DESCRIPTIVE REPORT

Type of Survey **Field Examination**

Project No. **F00490**

General Locality **Delaware River**

Chartlet 1 of 1 DtoN Report 1 (DtoN sounding in red)

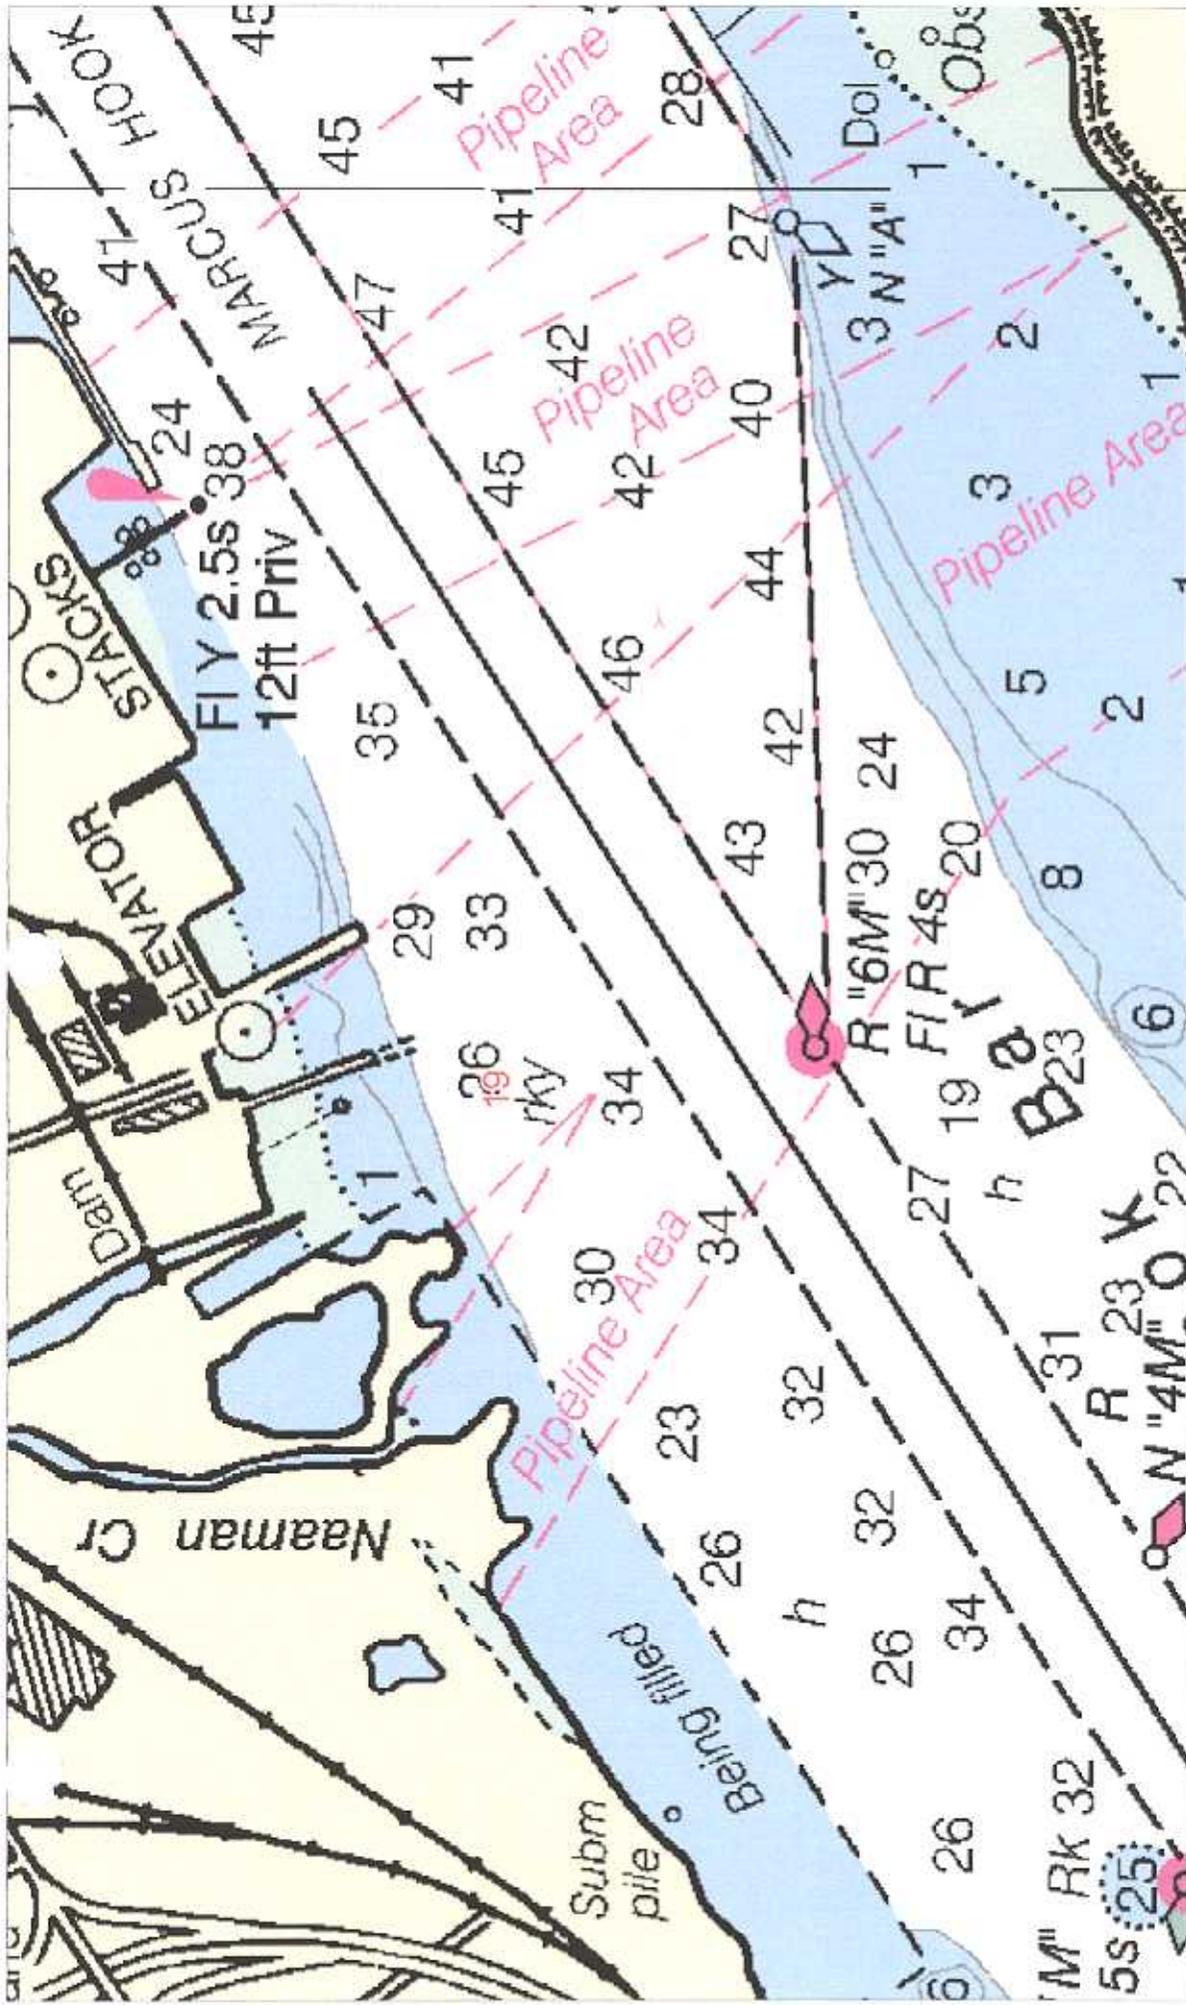
DTON #	LATITUDE	LONGITUDE	DEPTH	Type
1	39° 48' 01.614" N	75° 26' 02.777" W	19	Rock ✓

DfoN #7

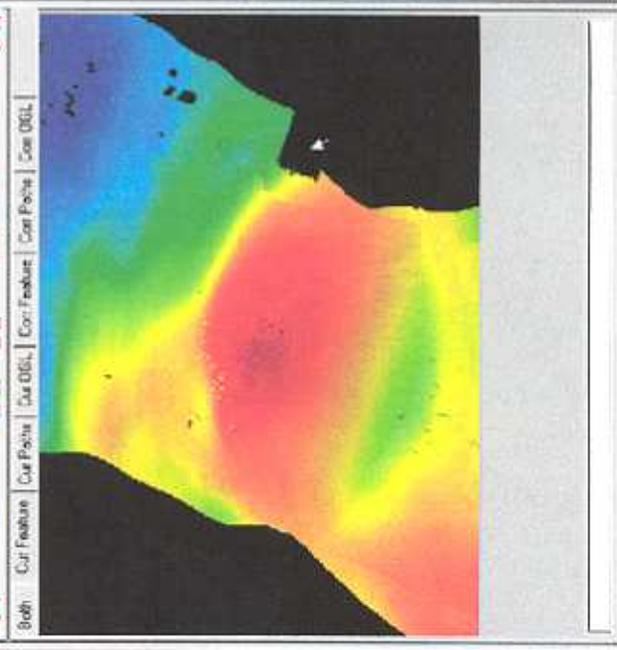
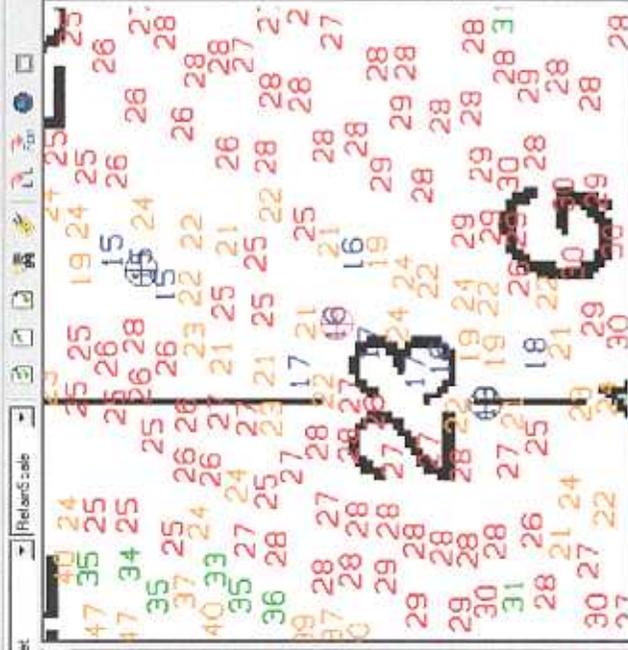
Note missing data on feature, due to survey geometry. Using 25m line spacing, full bottom coverage was not acquired. However, 100% SSS indicates that the feature is no shaller than the least depth acquired using SWMB
